# Accessibility Survey

# City of Downey La Reina Avenue - 5th Street to Firestone Boulevard

> Date of Inspection 7/24/2017

Prepared By Disability Access Consultants (800) 743-7067

#### Change in Level North of 3rd Street @ 33.943095155260, -118.133423477411

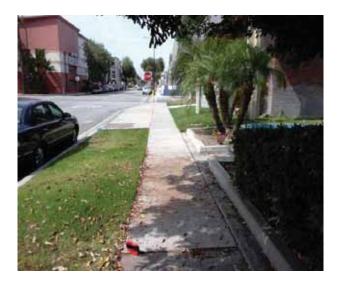
There is a change in elevation greater than recommended value.

On-Site Finding 0.62 inches

Ensure that the change in elevation is within the recommended value.

# Change in Level North of Firestone Boulevard @ 33.942315239910, - 118.134024292231

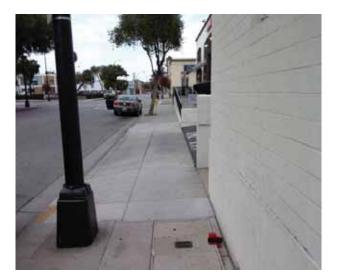
There is a change in elevation greater than recommended value.

**On-Site Finding** 1.50 inches

Ensure that the change in elevation is within the recommended value.

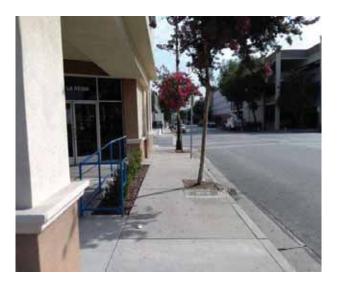
Sidewalk cross slope is not compliant.

On-Site Finding 3.30 percent for 51.00 feet

Repave the sidewalk surface with the recommended cross slope.

### Change in Level South of 7th Street @ 33.946408325124, -118.130729198456

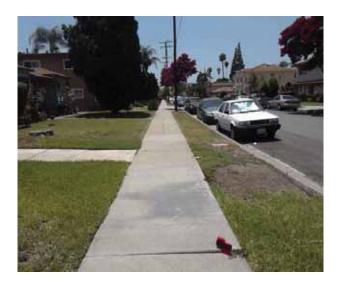
There is a change in elevation greater than recommended value.

**On-Site Finding** 1.00 inches

Ensure that the change in elevation is within the recommended value.

### Change in Level North of 5th Street @ 33.945122234204, -118.131862431765

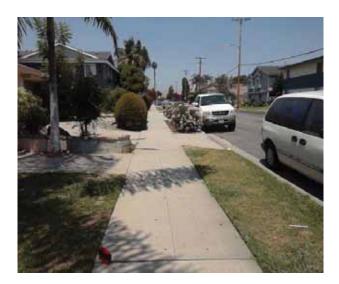
There is a change in elevation greater than recommended value.

**On-Site Finding** 0.50 inches

Ensure that the change in elevation is within the recommended value.

### Change in Level North of 6th Street @ 33.946708706882, -118.130709081888

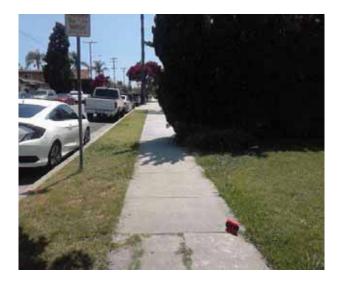
There is a change in elevation greater than recommended value.

**On-Site Finding** 0.50 inches

Ensure that the change in elevation is within the recommended value.

Sidewalks , Vehicular Traffic  $\ : \ \mbox{Cross Walks}$  and Detectable Warnings

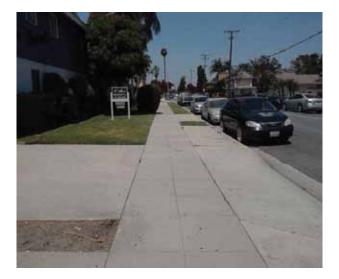
There are no detectable warnings where the pedestrian route crosses vehicular traffic.

**On-Site Finding** Not Found

Provide detectable warnings.

Sidewalks , Vehicular Traffic : Cross Walks and Detectable Warnings

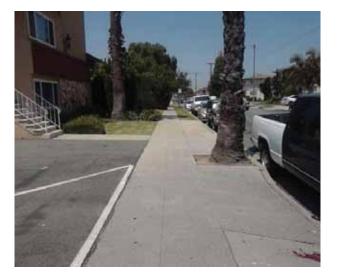
There are no detectable warnings where the pedestrian route crosses vehicular traffic.

**On-Site Finding** Not Found

Provide detectable warnings.

Change in Level South of Florence Avenue @ 33.946992399791, -118.130297362804

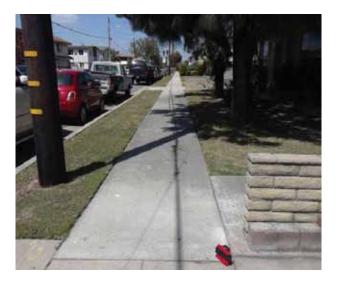
There is a change in elevation greater than recommended value.

On-Site Finding 0.37 inches

Ensure that the change in elevation is within the recommended value.

#### Change in Level North of 7th Street @ 33.947562007796, -118.130093514919

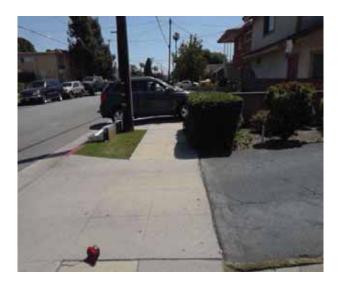
There is a change in elevation greater than recommended value.

On-Site Finding 0.37 inches

Ensure that the change in elevation is within the recommended value.

#### Change in Level North of 7th Street @ 33.948034824046, -118.129758238792

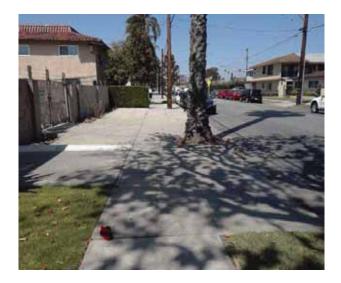
There is a change in elevation greater than recommended value.

**On-Site Finding** 1.00 inches

Ensure that the change in elevation is within the recommended value.

#### Change in Level North of 7th Street @ 33.948479825176, -118.129418939352

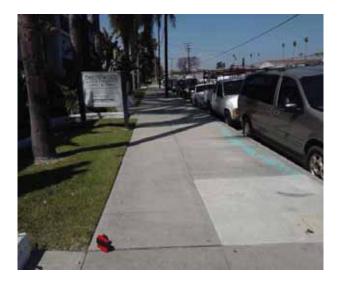
There is a change in elevation greater than recommended value.

**On-Site Finding** 0.50 inches

Ensure that the change in elevation is within the recommended value.

Sidewalks , Vehicular Traffic : Cross Walks and Detectable Warnings

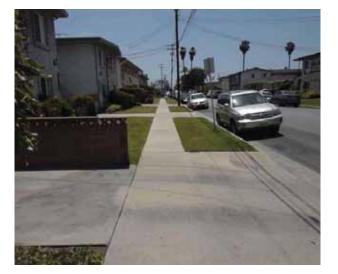
There are no detectable warnings where the pedestrian route crosses vehicular traffic.

**On-Site Finding** Not Found

Sidewalks, Vehicular Traffic : Cross Walks and Detectable Warnings

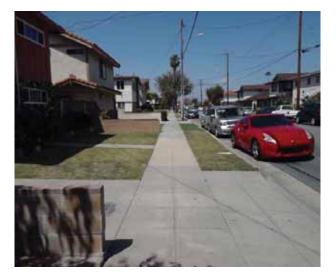
There are no detectable warnings where the pedestrian route crosses vehicular traffic.

**On-Site Finding** Not Found

Sidewalks , Vehicular Traffic : Cross Walks and Detectable Warnings

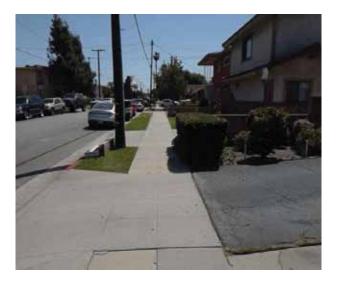
There are no detectable warnings where the pedestrian route crosses vehicular traffic.

**On-Site Finding** Not Found

Sidewalks , Vehicular Traffic : Cross Walks and Detectable Warnings

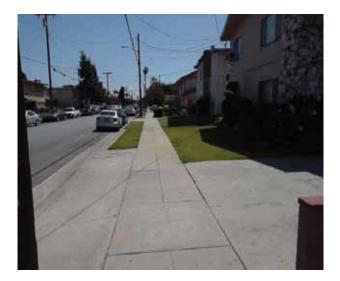
There are no detectable warnings where the pedestrian route crosses vehicular traffic.

**On-Site Finding** Not Found

Sidewalks , Vehicular Traffic  $\ : \ \mbox{Cross Walks}$  and Detectable Warnings

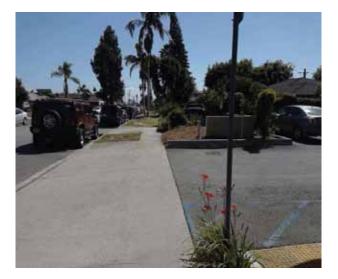
There are no detectable warnings where the pedestrian route crosses vehicular traffic.

**On-Site Finding** Not Found

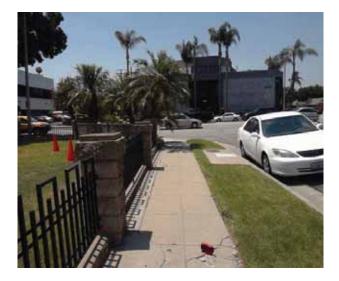
There is a change in elevation greater than recommended value.

**On-Site Finding** 0.50 inches

Ensure that the change in elevation is within the recommended value.

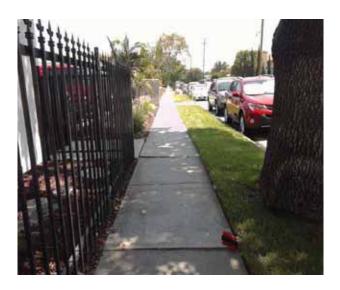
There is a change in elevation greater than recommended value.

On-Site Finding 0.62 inches

Ensure that the change in elevation is within the recommended value.

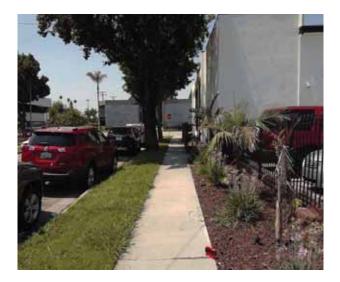
There is a change in elevation greater than recommended value.

On-Site Finding 0.50 inches

Ensure that the change in elevation is within the recommended value.

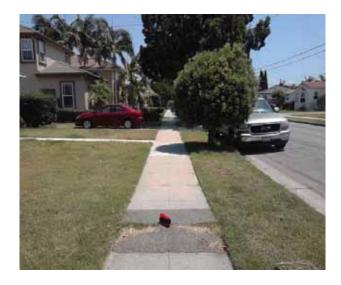
There is a change in elevation greater than recommended value.

**On-Site Finding** 1.00 inches

Ensure that the change in elevation is within the recommended value.

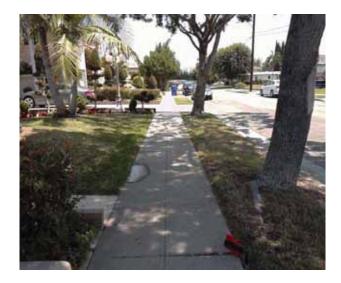
There is a change in elevation greater than recommended value.

**On-Site Finding** 1.00 inches

Ensure that the change in elevation is within the recommended value.

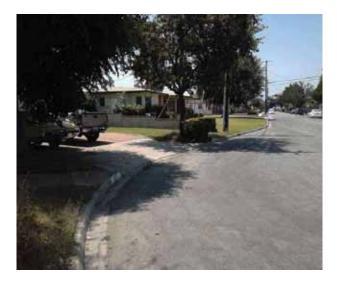
Section of sidewalk is missing and consists of dirt, grass or gravel.

On-Site Finding 163.00 feet

Provide a compliant sidewalk for the missing section.

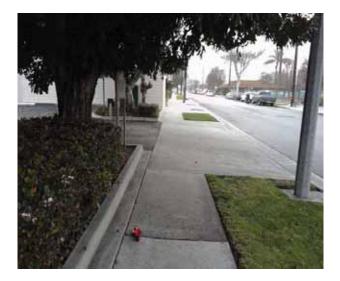
There is a change in elevation greater than recommended value.

**On-Site Finding** 0.50 inches

Ensure that the change in elevation is within the recommended value.

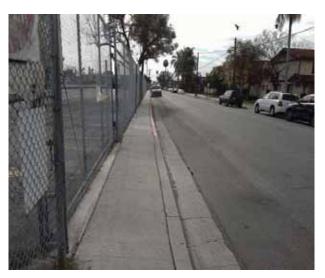
Cross slope at vehicular traffic is not compliant.

On-Site Finding 10.10 percent

Repave the surface to provide a compliant cross slope.

Sidewalks, Vehicular Traffic : Cross Walks and Detectable Warnings

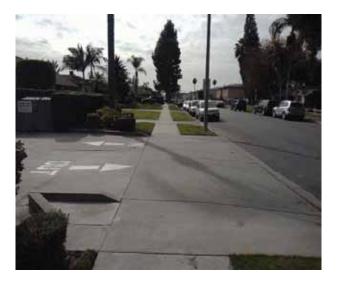
There are no detectable warnings where the pedestrian route crosses vehicular traffic.

**On-Site Finding** Not Found

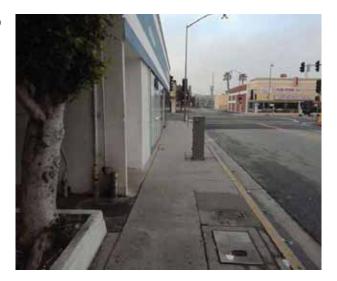
**On-Site Finding** Not Perpendicular

Grate opening shall be perpendicular to the path of travel.

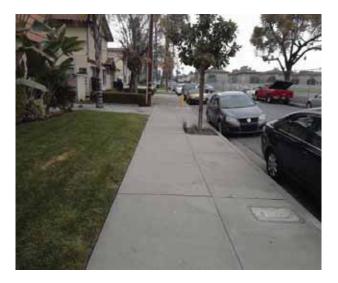
Sidewalk cross slope is not compliant.

On-Site Finding 3.10 percent for 15.00 feet

Repave the sidewalk surface with the recommended cross slope.

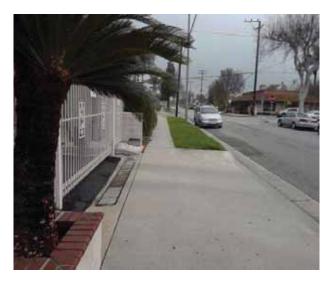
Overhead obstruction height is not compliant.

On-Site Finding 48.00 inches

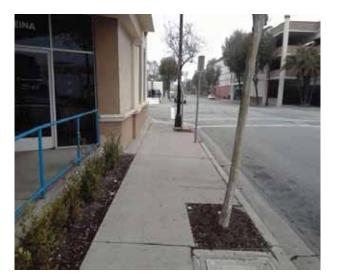
Sidewalk width at the obstruction is not compliant.

**On-Site Finding** 47.00 inches

Sidewalk width at the obstruction shall have the recommended value.

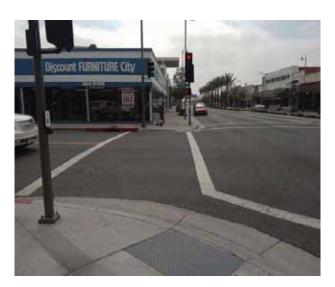
There are no detectable warnings provided for the crosswalk.

**On-Site Finding** Not Found

Provide compliant detectable warnings for the crosswalk.
